3.5 Traffic and Transportation Comments and Responses

Buena Vista Teutonia PUR

City of Yonkers, Westchester County, New York

Figure 3.5-1: On Street Parking Regulations

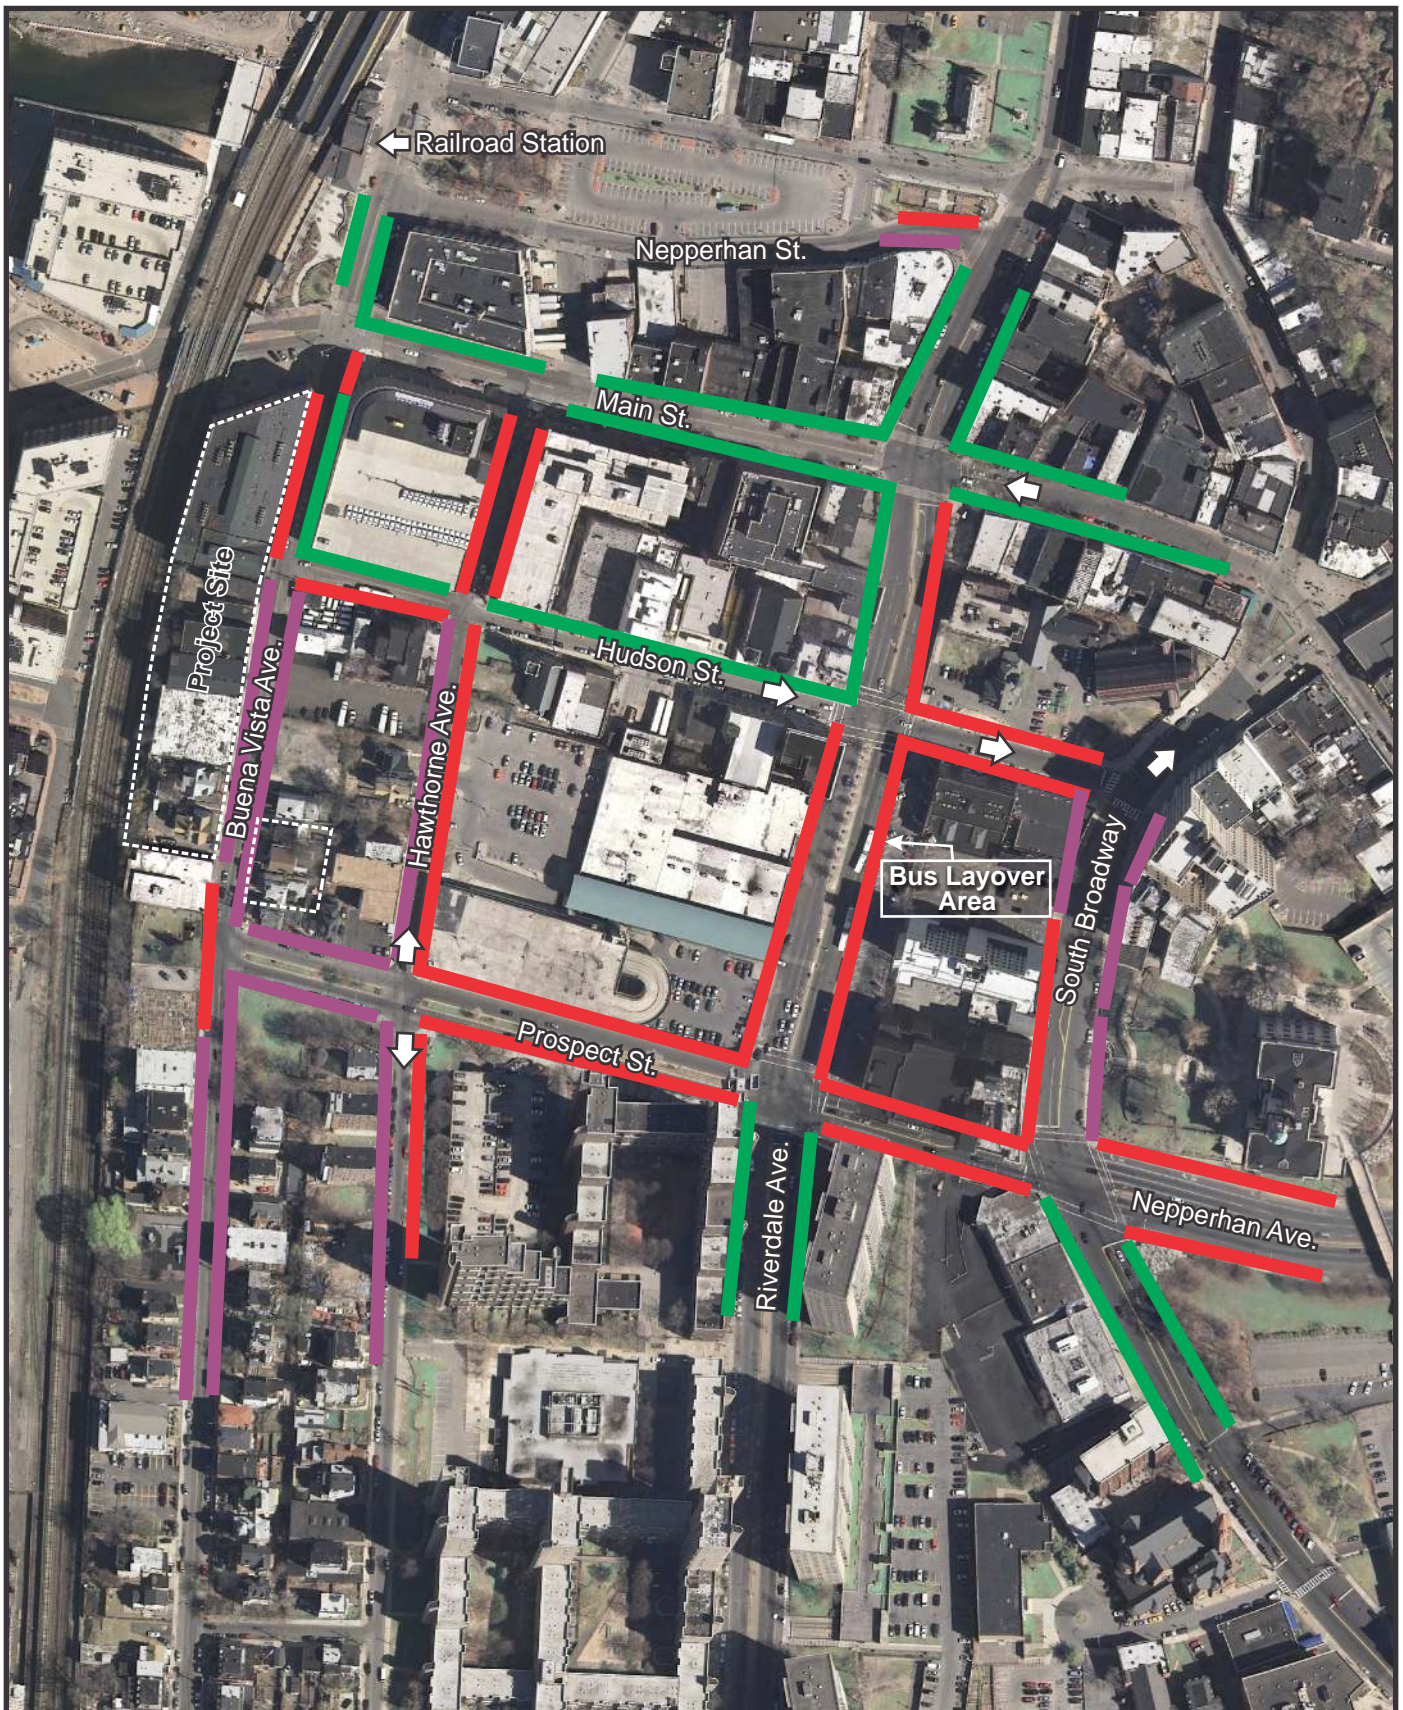
indicates that parking and bus blockage factors were not included in the analysis. These factors should be added to the analysis for each intersection where appropriate.

At signalized intersections the Highway Capacity Manual (page 16-10) and Synchro Studio 7 (page 6-5) notes that bus factor should only be used where buses block traffic in the lane group. Most of the bus stops are at locations where buses can pull over in bus stop zones not in the travel lanes. The bus layover area was not considered a travel lane although removal of the buses and creation of a new travel lane was discussed as a possible consequence of a separate proposal for a bus center. DEIS Figure 3.5-5 has been updated for the FEIS (Figure 3.5-1) showing parking in additional areas.

Figure 3.5-2: West Bound Nepperhan Ave. Left Lane Extension
 Buena Vista Tuetonia PUR
 City of Yonkers, Westchester County, New York
 Base Map: Google Maps

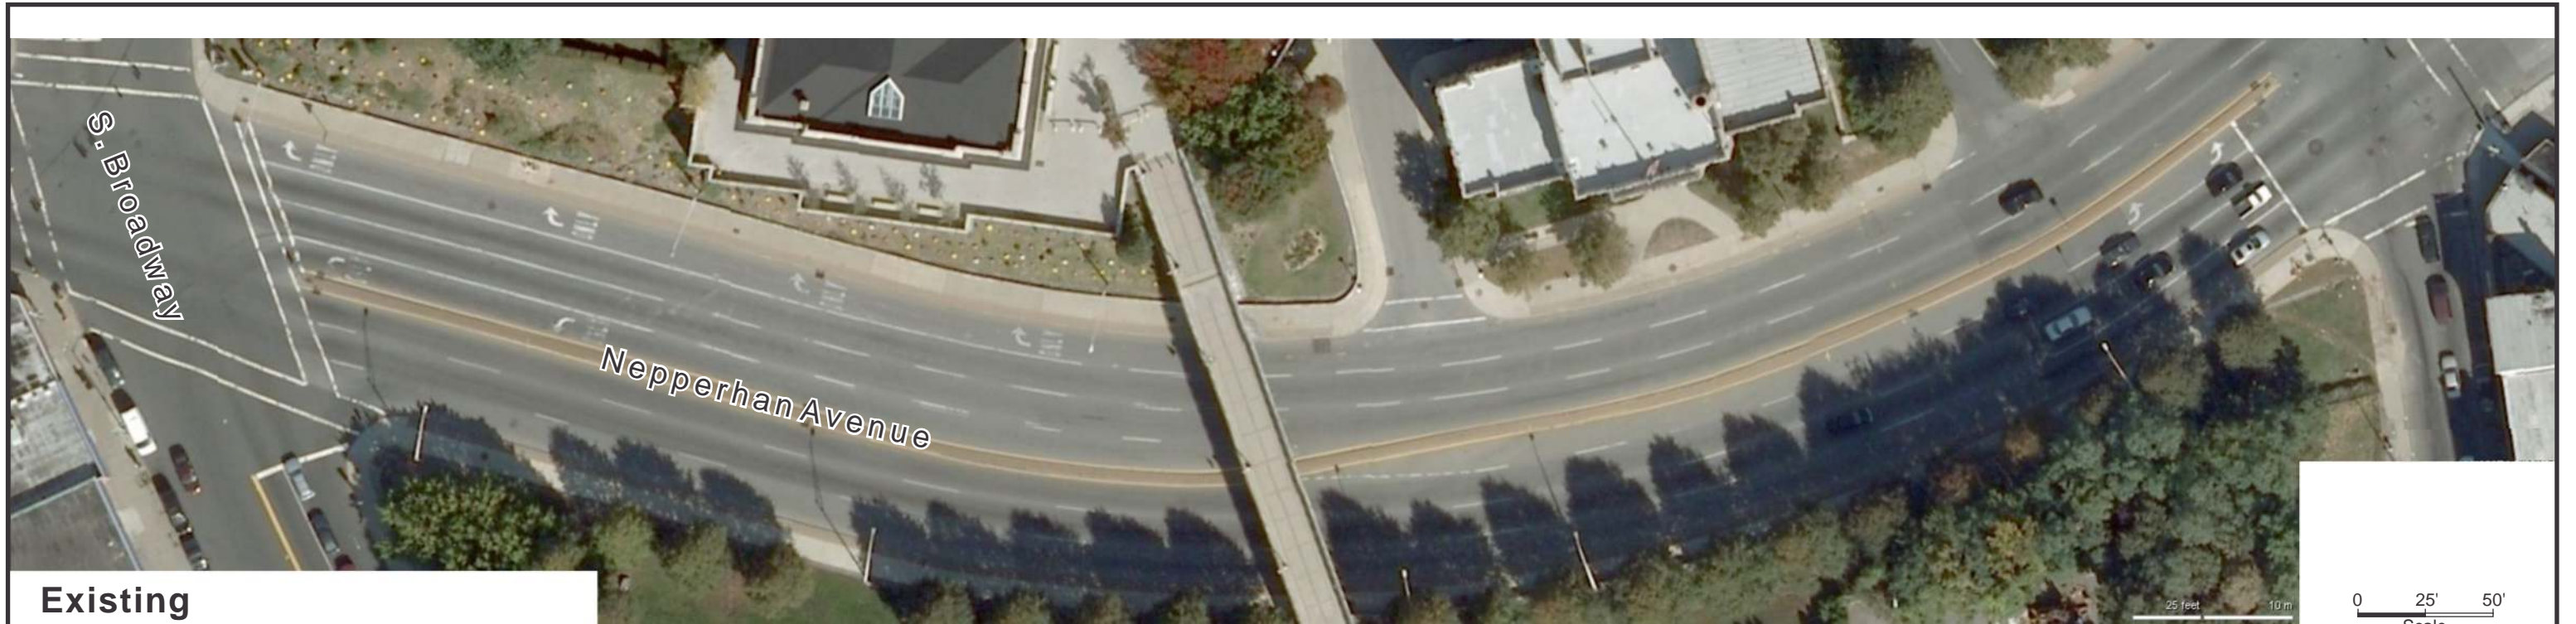
Comment 3.5-23 (Letter 16, January 19, 2011, Philip Grealy, Ph.D, JCE - City Traffic Consultant): **Westbound left turn movement at the intersection of S. Broadway and Prospect Street/Nepperhan Avenue** - The DEIS indicates that the westbound left turn lane can be extended by shortening the eastbound left turn lane at the school street intersection which is currently significantly under utilized. A conceptual plan should be prepared so that it can be reviewed by the City.

Response 3.5-23: *A concept plan has been included as Figure 3.5-2.*

Based on the DEIS Build Condition and Sensitivity analysis the Applicant is not proposing any changes to the subject intersection. These analysis show that without SFC development the intersections show no overall level of service change with the Buena Vista Teutonia PUR project development. See Table 3.5-1 in response 3.5-28. Furthermore, as discussed in Response 3.5-23 the Applicant has provided mitigation by developing a concept plan, Figure 3.5-2, for improving the westbound Nepperhan Avenue queue storage.

Figure E-1: Sensitivity Arrival/Departure Distribution of Site AM Peak Hour Traffic
 Buena Vista Teutonia PUR
 City of Yonkers, Westchester County, New York
 Base Map: NYS DOT Planimetric Map, Yonkers Quad, 1990
 Scale: 1" = 700'

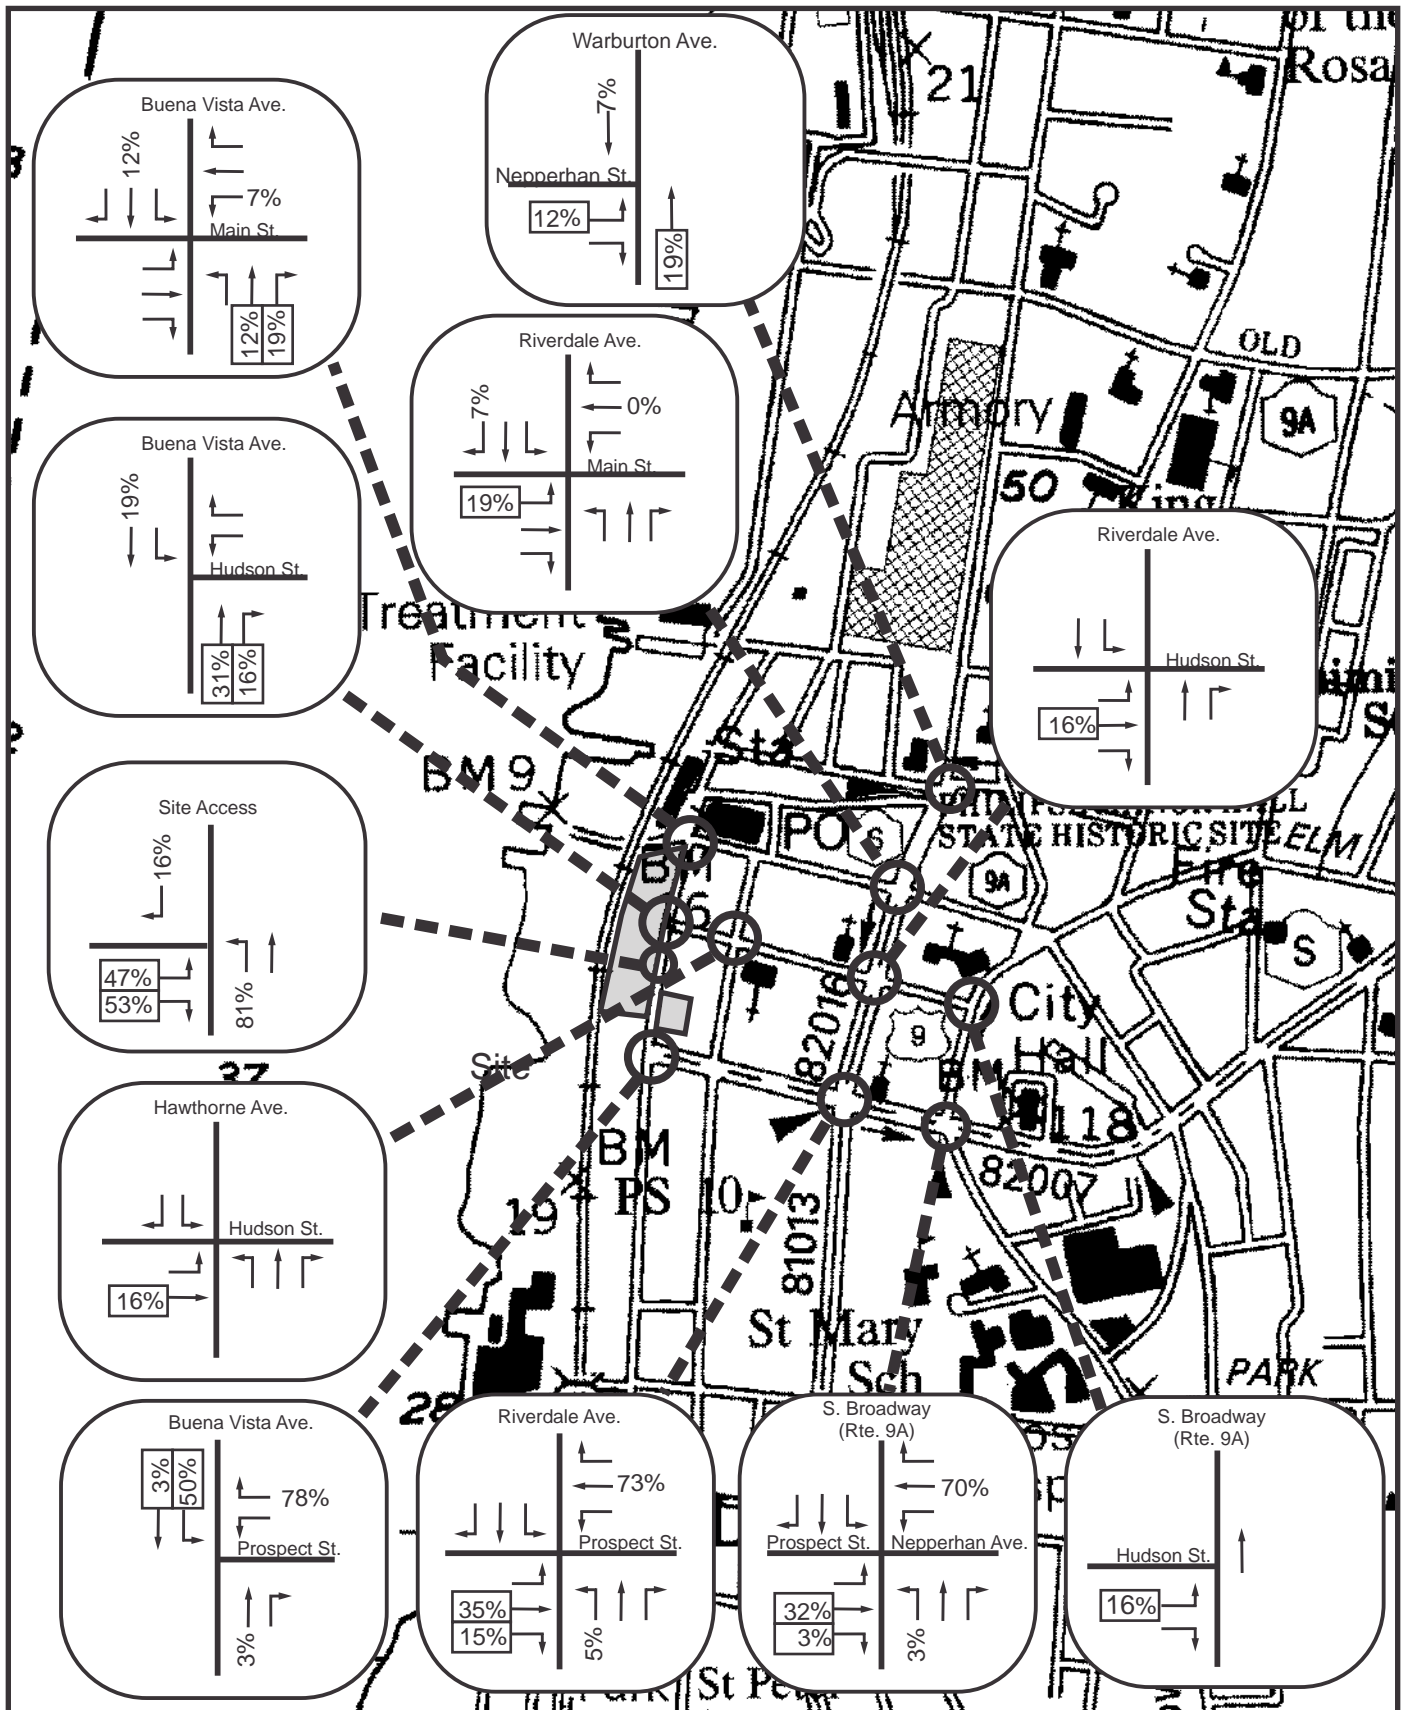
Comment 3.5-28 (Letter 16, January 19, 2011, Philip Grealy, Ph.D, JCE - City Traffic Consultant): A sensitivity analysis should be conducted for the intersections of Nepperhan Avenue and S. Broadway and Prospect Street and Riverdale Avenue using higher existing traffic volumes similar to those used in the SFC report. This sensitivity analysis should also evaluate whether these intersections can accommodate traffic conditions with 70% of the traffic arriving from the east on Nepperhan Avenue.

Response 3.5-28: *The shift of site generated traffic to 70 percent from Nepperhan Avenue is presented based on SFC distributions. The resulting site generated traffic distributions at these intersections is shown in Appendix E Figures 1 and 2. Trips through the Prospect Street and Riverdale Avenue intersection would increase by 9 trips in the a.m. peak hour and 14 trips in the p.m. peak hour. Trips through the South Broadway and Nepperhan Avenue intersection would increase 11 trips in the a.m. peak hour and 21 trips in the p.m. peak hour. Because the projected new inbound trips to the site are 30 a.m. peak hour trips and 70 p.m. peak hour trips, even large shifts in the site generation distribution result in small volume shifts. For example, the largest shift of 21 vehicles is a result of a 30 percent shift in traffic distribution.*

Lower Hudson Line Trains AM Peak Hour Inbound Percent Utilization Figure E-3

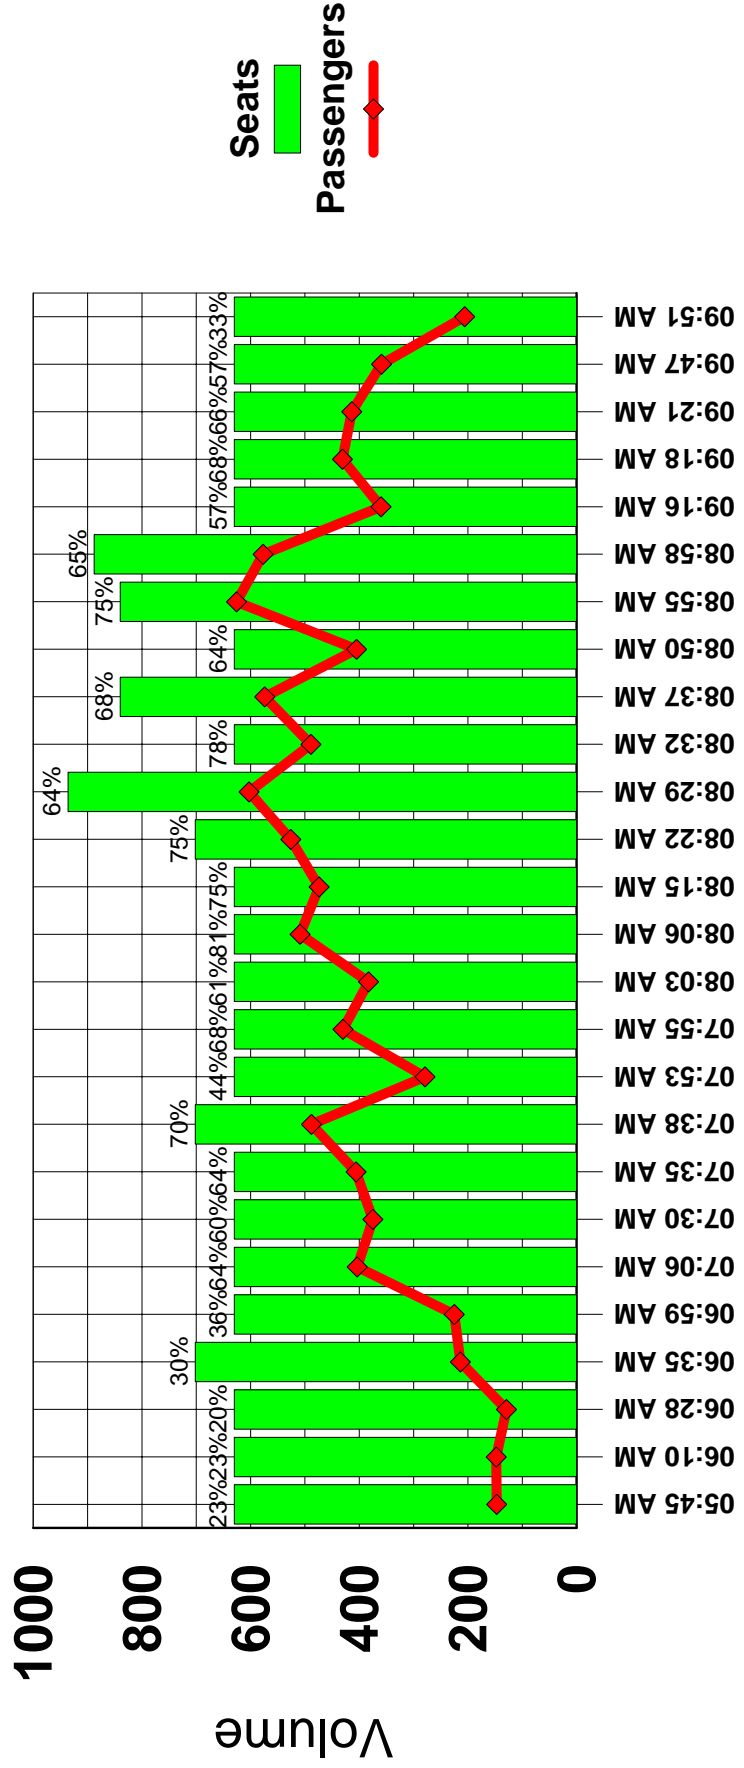
Mass Transit Page 3.5-14 The fact that there are a number of Metro North Trains available and that the number of potential users equates to 1 per train does not equal “sufficient capacity exists to handle projected transit ridership...” What is the capacity of the peak hour trains? If they are at or over capacity one additional passenger puts the train beyond “sufficient capacity.” A statement by Metro North personnel would be sufficient.

Response 3.5-40: *The MetroNorth Lower Hudson Line which includes the Yonkers Station has peak trains running at or below 81 percent of capacity at Grand Central Station. FEIS Appendix E Figure E-3 and E-4 show the number of seats by train and maximum passenger load based on Spring 2011 counts at Grand Central Station.*
